18 August 2020

Our Ref: P-20128 (TW/MS)

RE: SSD-10375 - IMPACTS OF PROPOSED PITT STREET NORTH OVER STATION: STAGE 2 DEVELOPMENT - CASTLEREAGH BOUTIQUE HOTEL AND NSW MASONIC CLUB

Figure 8: Requested amendments to proposed setbacks on (Source: Plans by Foster & Partners et al with annotations by NSW Masonic Club)

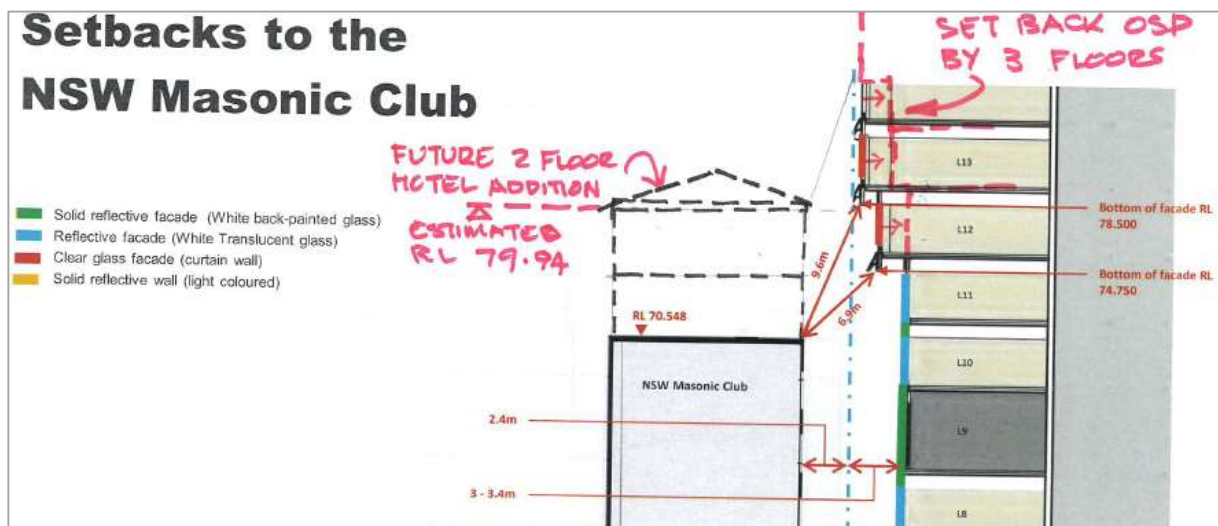
The proposed buildings setbacks to the lightwell have been prepared based on the Club being two storeys lower in height. This is significant because the size of the opening to the lightwell is significantly reduced, when the Clubs approved additional storeys are taken into account (Figure 8).

As described in Point 1, the opening to the lightwell has been designed on an erroneous understanding of the Club's development capacity. The proposed setbacks are not sufficient to protect light access to the lightwell when the approved development capacity of the Club is taken into account. It is important to note that the proposed lightwell also includes three transfer columns which land adjacent to a number of windows and are likely to affect light penetration into the lightwell and adjacent rooms.

The proposed development is therefore inconsistent with Condition B2 of the Concept Approval and cannot be approved in its current form. We request therefore that proposed levels 12 - 14 are setback to achieve the intended opening to the lightwell as is shown in Figure 8.

Figure 9: Requested amendments to proposed setbacks on Level 4 (Source: Plans by Foster & Partners et al with annotations by NSW Masonic Club)

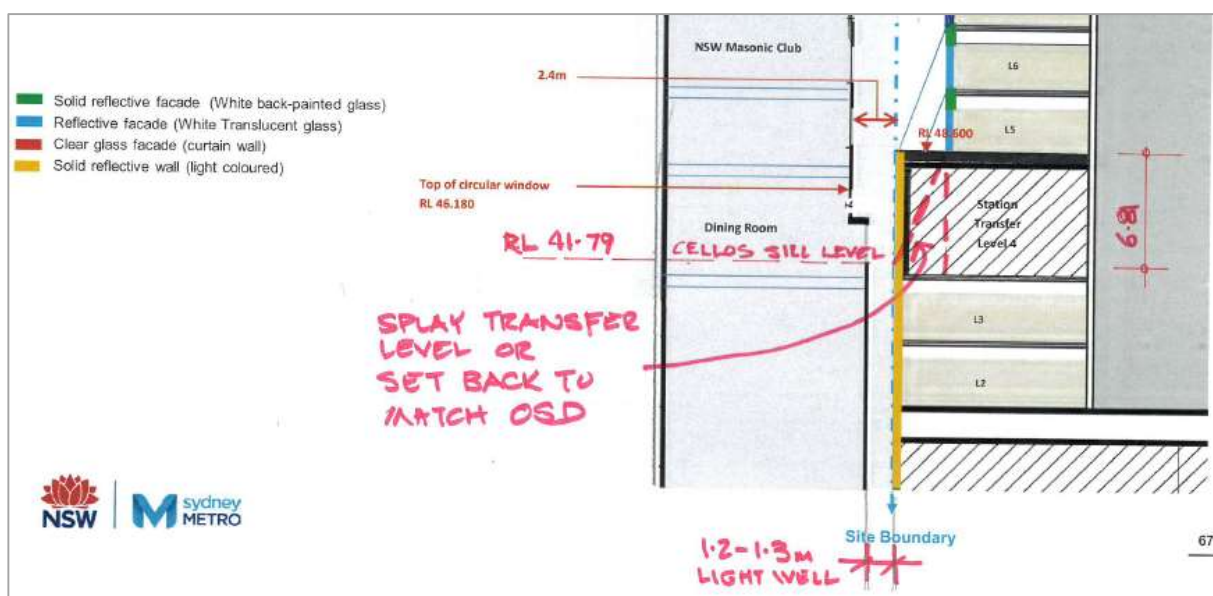
It is our understanding the Station Box was approved at a height of RL39 by the Minister and later increased to RL48 by Sydney Metro through a consistency assessment process. The Club is extremely disappointed it was not consulted during the consistency assessment process as it has raised the station box above the level of the windows of Cellos.

The proposed station box is built to the side boundary. Cellos has high ceilings, with the lower portion of the walls having bay windows, with circular highlight windows located in the upper section as shown in the Figures 2-4. A reduction in light to those windows will significantly affect the amenity of the room.

We therefore request that the Department make representations to Sydney Metro about splaying the setback of the Station transfer level to achieve the built form outcome intended by the Minister's approvals, that being reasonable light access to the lightwell and the historic rooms it serves.
